SERVICE LETTER

No. 701

Piper Aircraft Corporation

Wiring of Overvoltage Relays -- Alternator Paralleling System

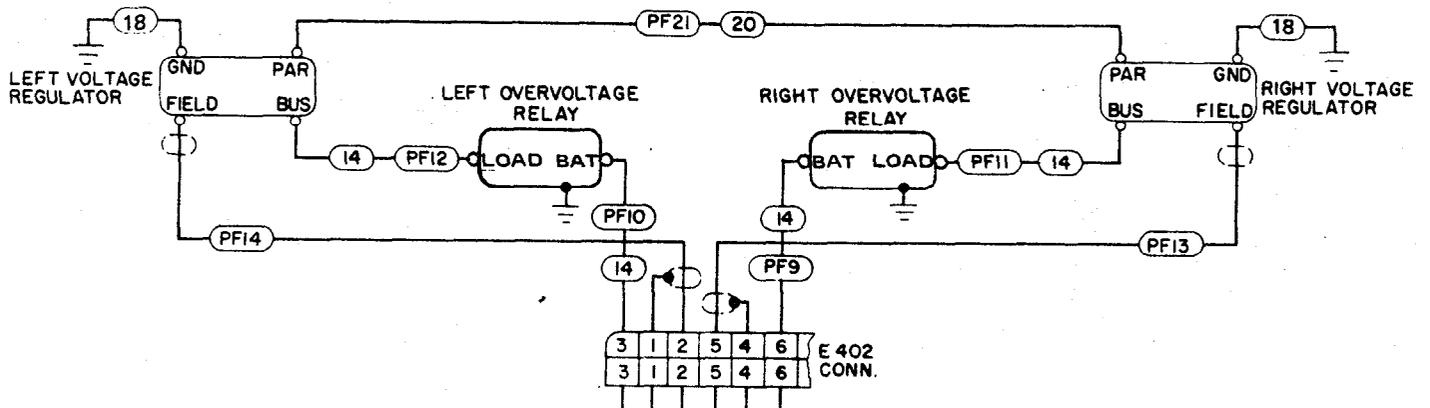
In the existing Electrical System section of the PA-31P Service Manual (Section XI), Figure 11-11a, Page 11-12a, contains an electrical system wiring schematic relative to the alternator paralleling system. It has been brought to our attention that the left and right overvoltage relay terminal connections have not been identified as to which terminal is "battery" and which is "load".

The objective of this service release is to advise owners/operators of the above referenced aircraft that have had overvoltage relays replaced and/or rewired in the field to have the overvoltage relays rechecked to insure the proper terminal connection, in accordance with the attached sketch -- which clearly specifies the overvoltage relay "battery" and "load" terminals.

1. Remove access panel from left side of forward fuselage to gain access to the electrical accessory shelf.
2. Inspect wiring on left and right overvoltage relays to determine if wires on "BAT" and "LOAD" terminals are correctly wired as shown on above schematic.
3. Correct wiring if required and reinstall access panel.
4. Check operation of overvoltage relays in accordance with Overvoltage Relay Test Information, Section XI, Pressurized Navajo Service Manual.

1. If overvoltage relay has been replaced/rewired in the field, check overvoltage relay wiring in accordance with the attached sketch.
2. If the overvoltage relay is properly wired, no further action is required.
3. If the overvoltage relay is improperly wired, rewire per attached sketch; then check the function of the overvoltage relays in accordance with Overvoltage Relay Test Information, Section XI, Pressurized Navajo Service Manual.
